NRDC Comments on the 2016 Draft Title 24 Building Energy Standards
November 24, 2014

Figure 3: Energy Savings and Incremental Cost Analysis for assemblies with U=0.046 and below.⁴

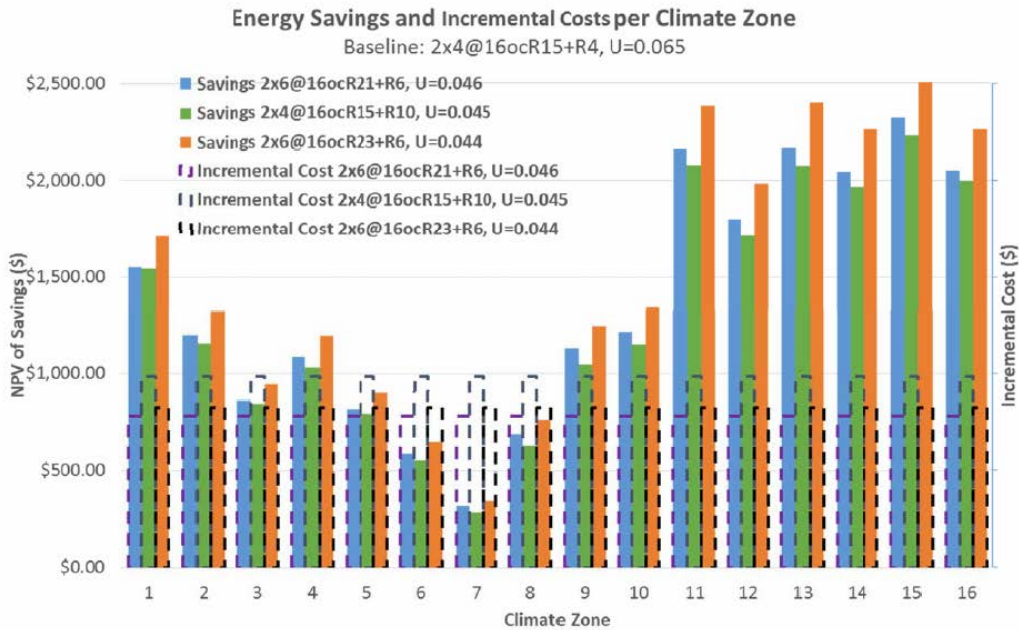
- **High Performance Walls:** NRDC strongly supports updating the residential wall insulation requirements. While the proposed values are a step in the right direction, they stop short of what is cost effective. For a small additional upfront cost (see Figure 3), the standards can achieve additional energy savings that will pay back over the life of the home. It makes much more sense to add this additional insulation at the time of construction when the wall is already open, rather than having to add it later as a retrofit. Furthermore, failing to adopt cost-effective opportunities now could short-circuit the CEC's ability to achieve ZNE by 2020 as builders will not gain experience with efficient construction practices, which could limit future innovation. We recommend that the CEC revise its proposal to be a maximum of $U=0.44$ in all climate zones as discussed in detail below.

The CEC proposes increasing the wood-frame wall U-factor to U=0.05 in all climate zones. However, the CASE report found that a U-factor of U=0.044 would be cost-effective in almost all climate zone (except climate zones 6-8). The CASE report recommended a U-factor of U=0.046 which corresponded to the highest level evaluated using 2x4 studs. We recommend that the CEC modify the proposed standards to require a U=0.044. Stopping short of the highest levels found to be cost-effective is likely to impede efforts to reach zero net energy by 2020. Setting levels at the highest level that are cost-effective will allow builders to become more familiar with construction techniques to reach these levels, potentially leading to innovation and further cost-effective savings in the future. Alternatively, failing to adopt the highest cost-effective levels now could limit future savings opportunities.

Additionally, the CEC should require a U-factor of U=0.044 in all climate zones, even though the CASE analysis did not show it to be cost-effective in climate zones 6-8. There are several reasons for this. First, the CASE report does not take into account any reduced equipment costs from smaller equipment enabled by the reduced heating and cooling loads that come with increased envelope insulation. Therefore, the CASE report most likely overestimates the cost of reaching a given U-factor in all climate zones. If these costs were taken into account it is probable that a U=0.044 would be cost-effective in all climate zones. Secondly, the CEC would most likely find a U=0.044 to be cost-effective in all climate zones even without taking into account reduced equipment costs, if evaluated compared to historic practice (rather than the most recent standard), as the Warren-Alquist Act requires. Finally, the Warren-Alquist Act also requires that the standards be cost-effective in total, not that every proposed change be cost-effective. The increased cost of a U=0.044 in climate zones 6 through 8 will likely be offset by savings from other measures, resulting in standards that are cost-effective overall.
